Detailed Site Plan Dash-In Bowie

DSP-22016

STAFF REPORT

SUBJECT: Detailed Site Plan DSP-22016
Dash-In Bowie

Figure 1: Front Elevation (Facing East) of the Food or Beverage Store

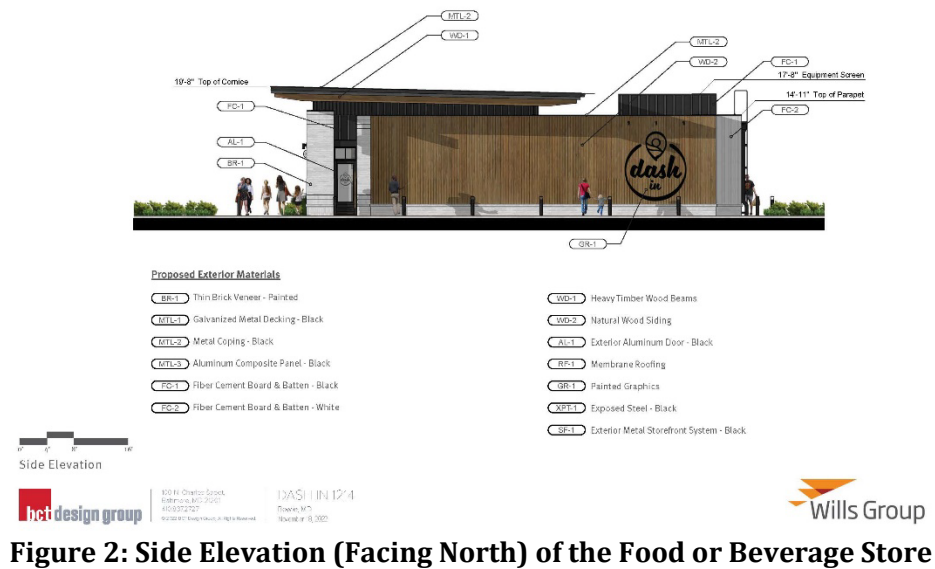
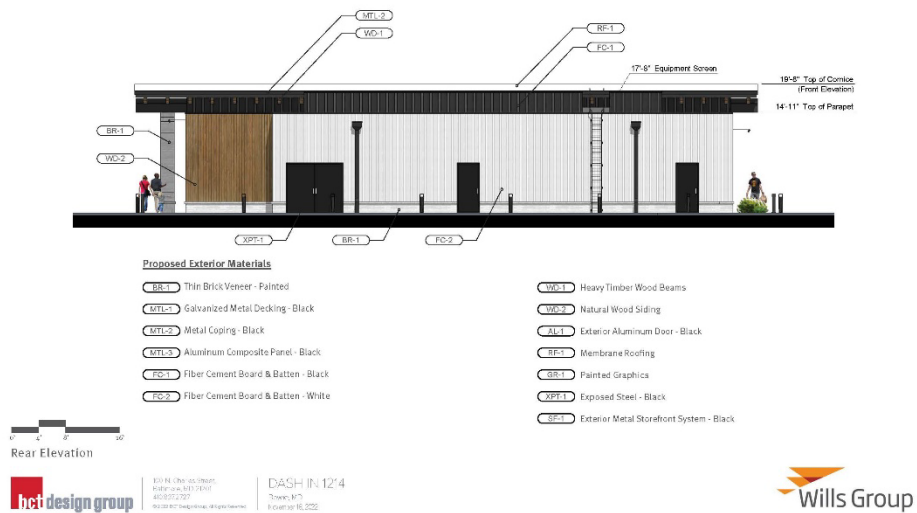
The building materials will include brick veneer, metal coping, aluminum, glass, and wood that will be in multiple colors including black, white, and brown. Separate architectural elevations are provided and are acceptable, but conditions have been included to label the cardinal directions on the elevations, and to dimension more architectural features.

- k. Provide a signage chart stating the required maximum and provided signage amounts.
 - l. Provide cardinal directions for all architectural elevations.

- m. Provide dimensions for architectural elevations, including building widths and measurements for major features, such as entrances.
 - n. Modify the site layout to allow for a 30-foot driveway width from the site access point on Heritage Boulevard, to the proposed intersection with the east/west drive aisle to the south of the proposed building. The exact design shall be evaluated and accepted by the Transportation Planning Section.
